ENVIRONMENTAL COMMISSION MOTION 20221102-002

Subject: Brodie Oaks Redevelopment PUD, C814-2021-0099

NAME & NUMBER OF PROJECT: Brodie Oaks Redevelopment PUD C814-2021-0099

Subject: Brodie Oaks Redevelopment Site Specific SOS Amendment, C814-2021-0099

Exhibit F: Environment

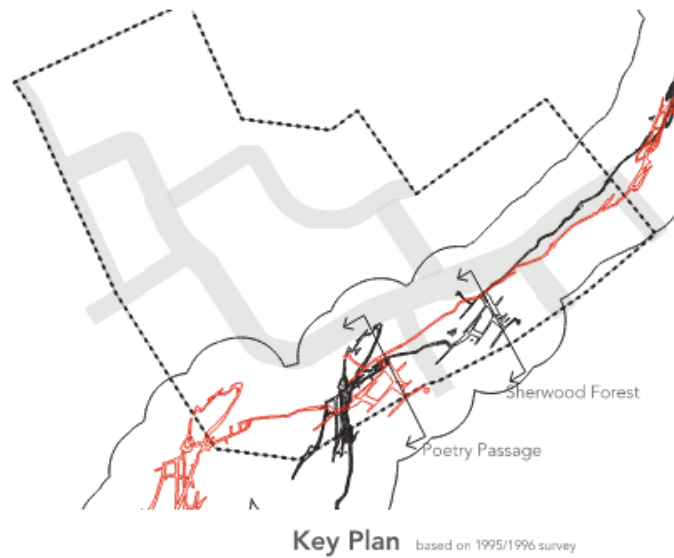
1. Modify CEF setback for S-1/S-2
2. Impact to Airman's Cave CEF setback is limited of up to 80' with conditions
3. Protective fencing for CEFs

Exhibit F: Water Quality

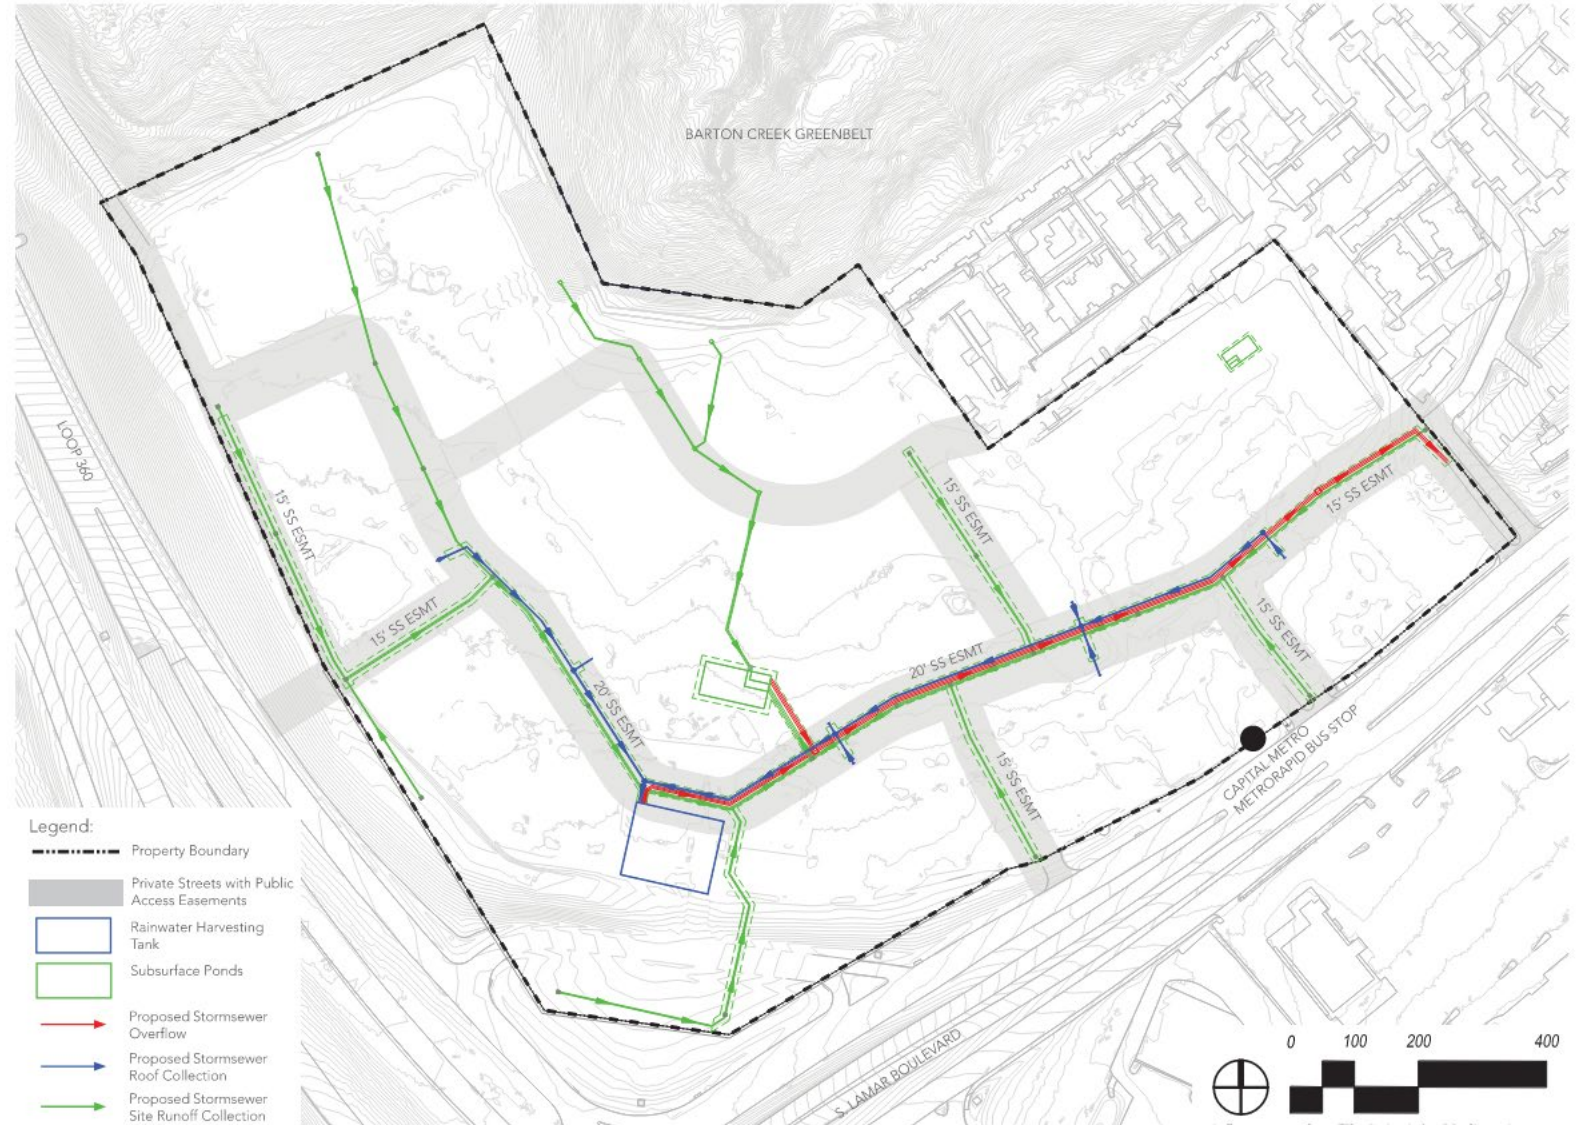
1. Brodie PUD will comply with SOS with subgrade ponds for retention/reirrigation system and rainwater harvesting with beneficial reuse
2. Infiltration testing
3. Trenching > 5' will be inspected by geologist
